# COMMUNITY MASTER PLAN

LEVEL B PLAN: AS APPROVED BY DEVELOPMENT REVIEW BOARD FEBRUARY 2008

PROPOSED AMENDMENT NOVEMBER 2022

Mesa del Sol

Figure 4-2

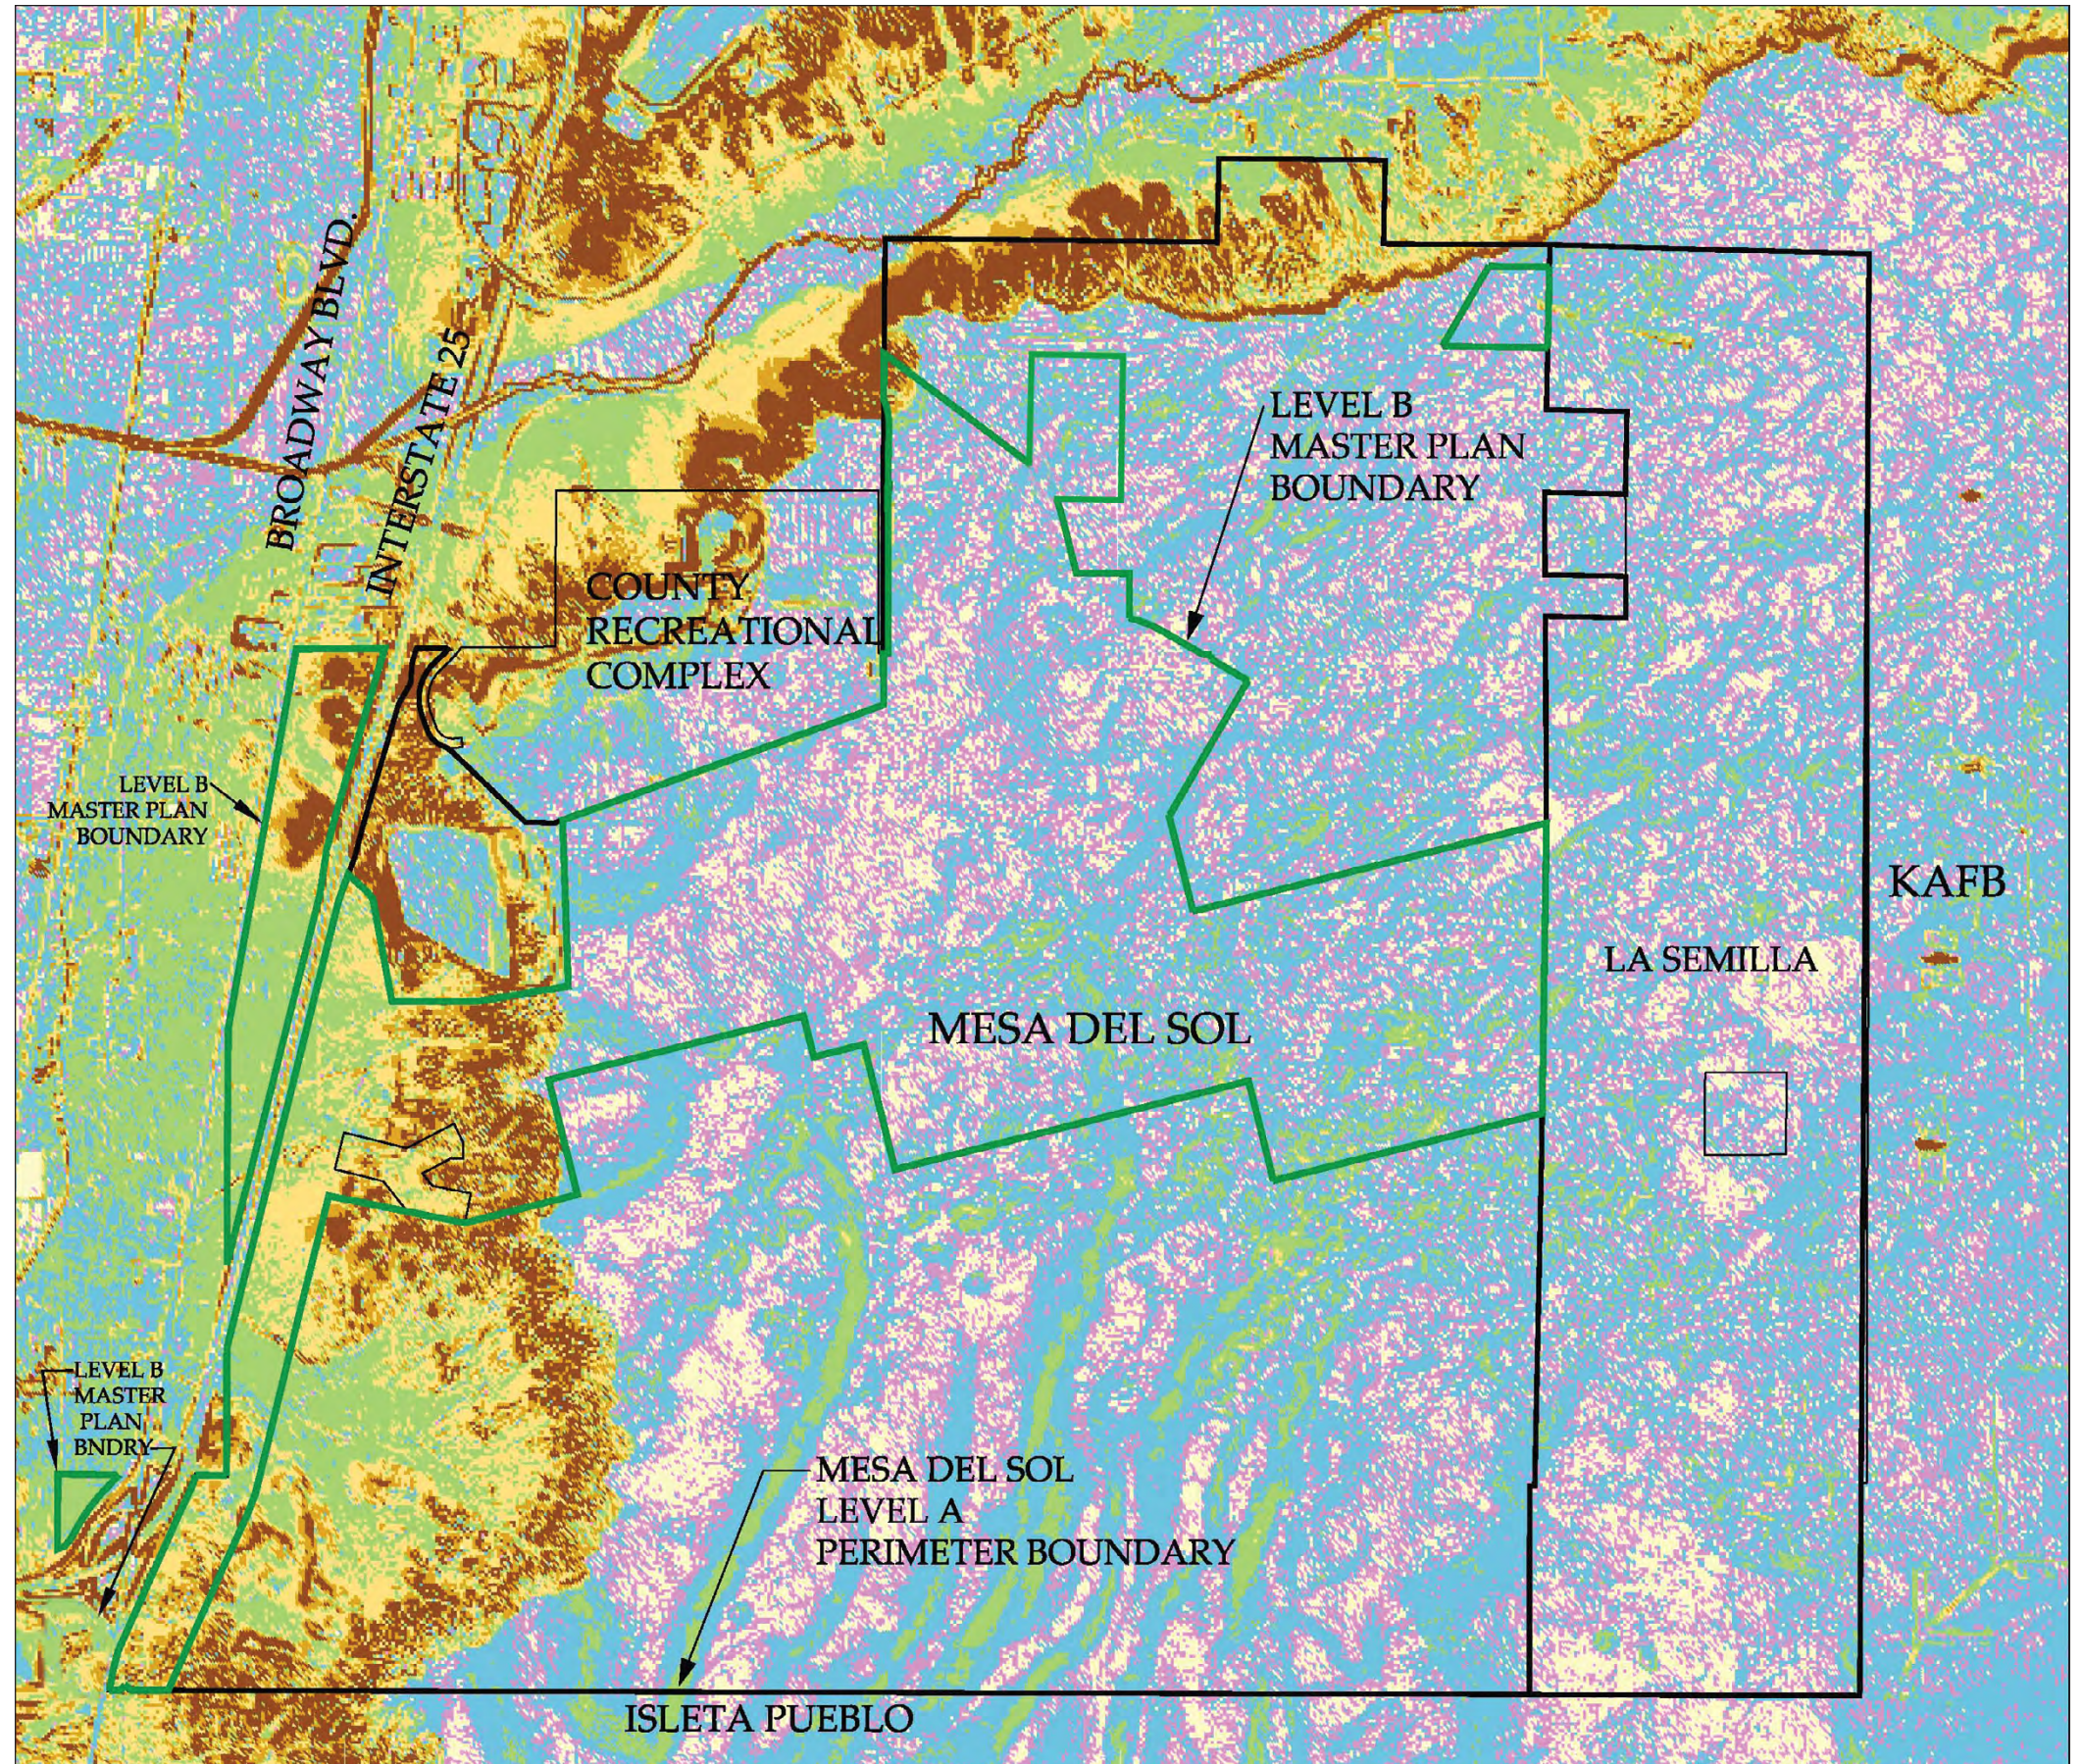
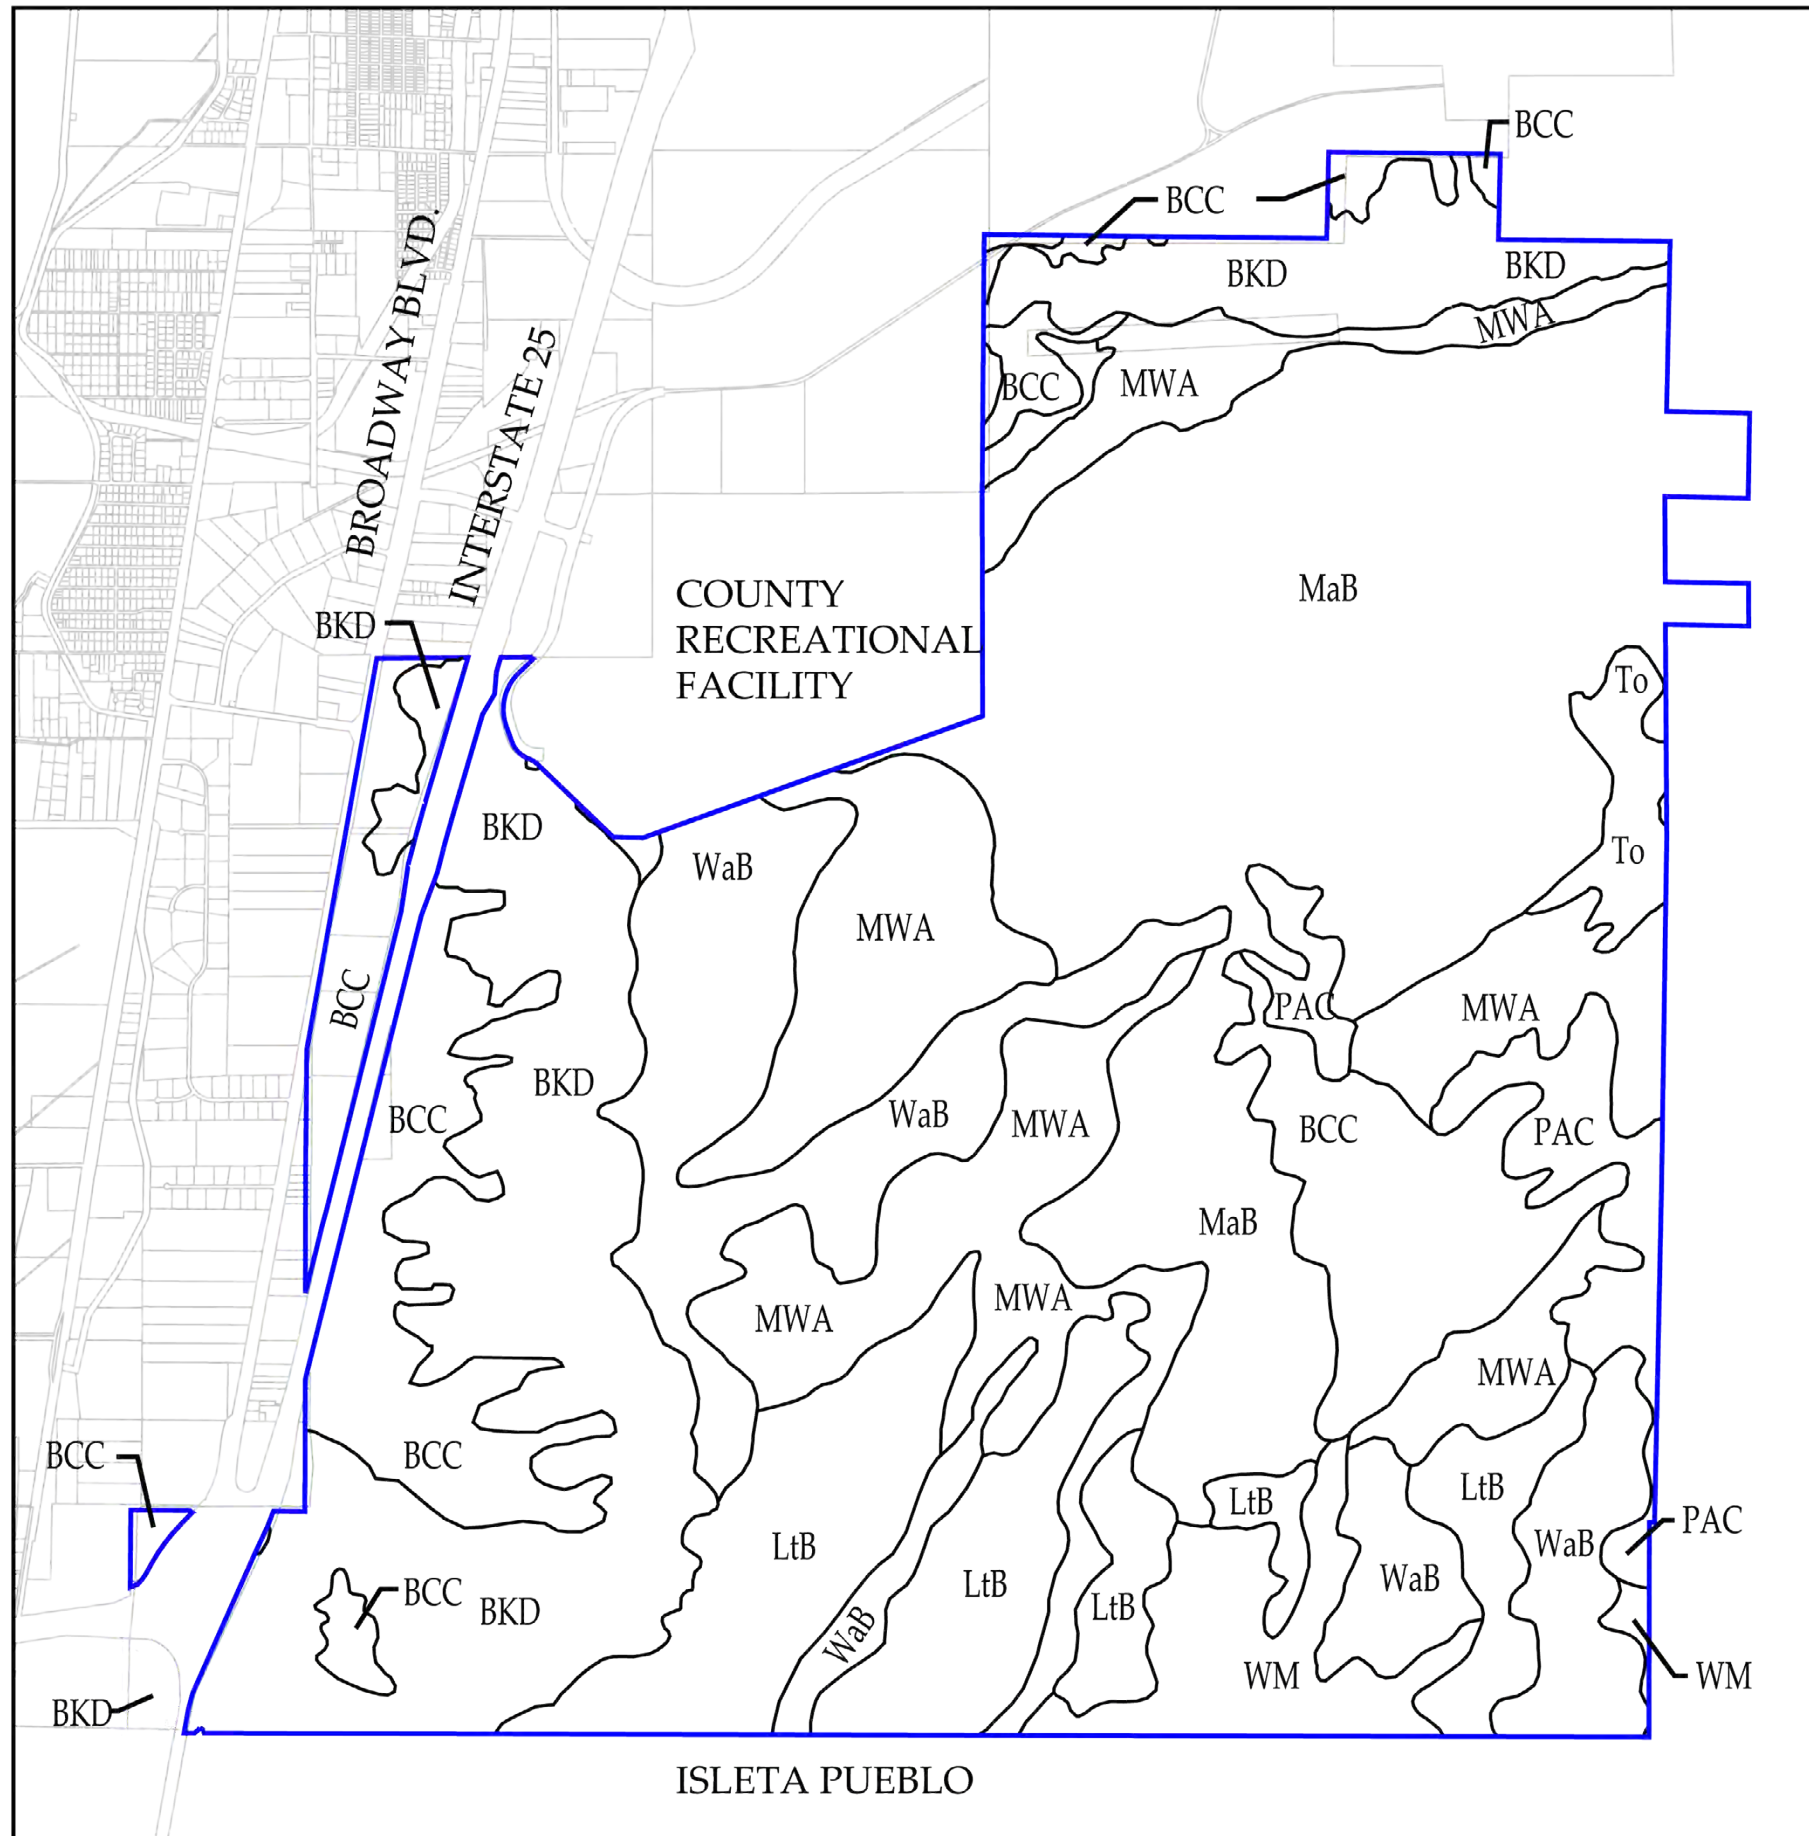
Revised September 2012 - addition of Tract D and removal of Tract 8 from plan area.

Revised September 2012 - removal of Tract 8 from plan area

Figure 5-6

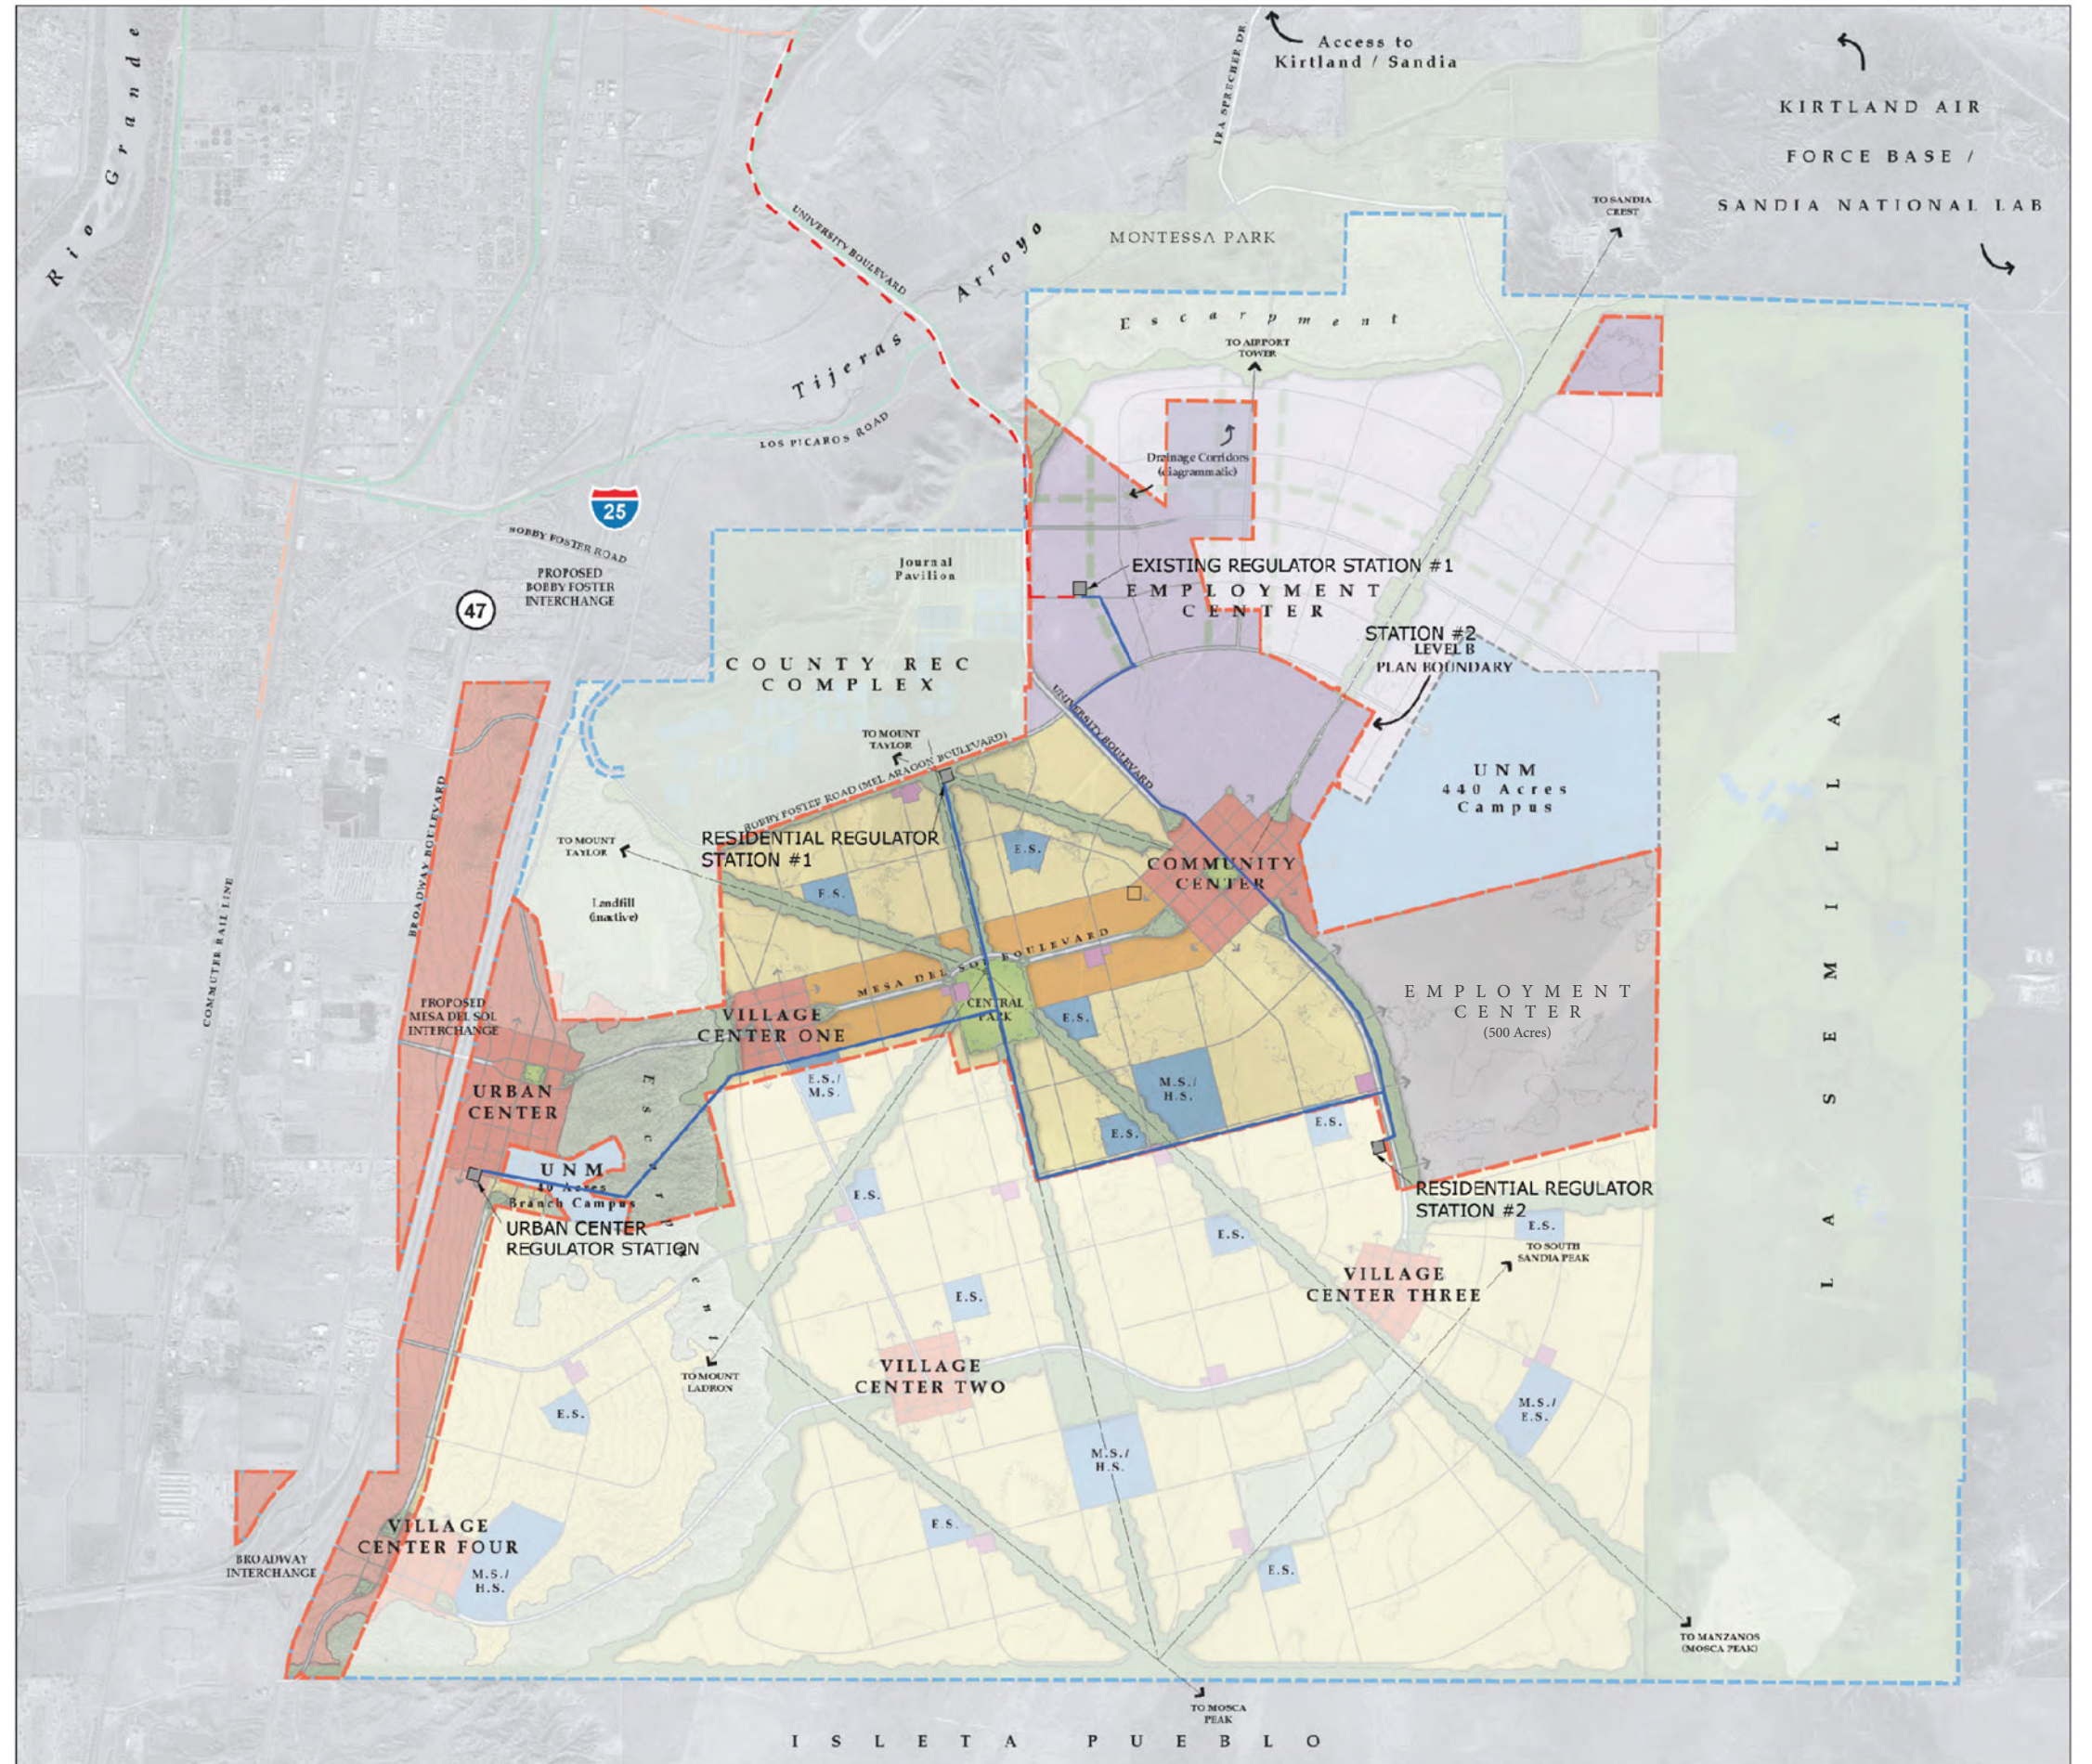
Revised September 2012 - addition of Tract D and removal of Tract 8 from plan area.

Revised August 2021 - modifications to utility corridors within a southern portion of the Employment Center, as shown.
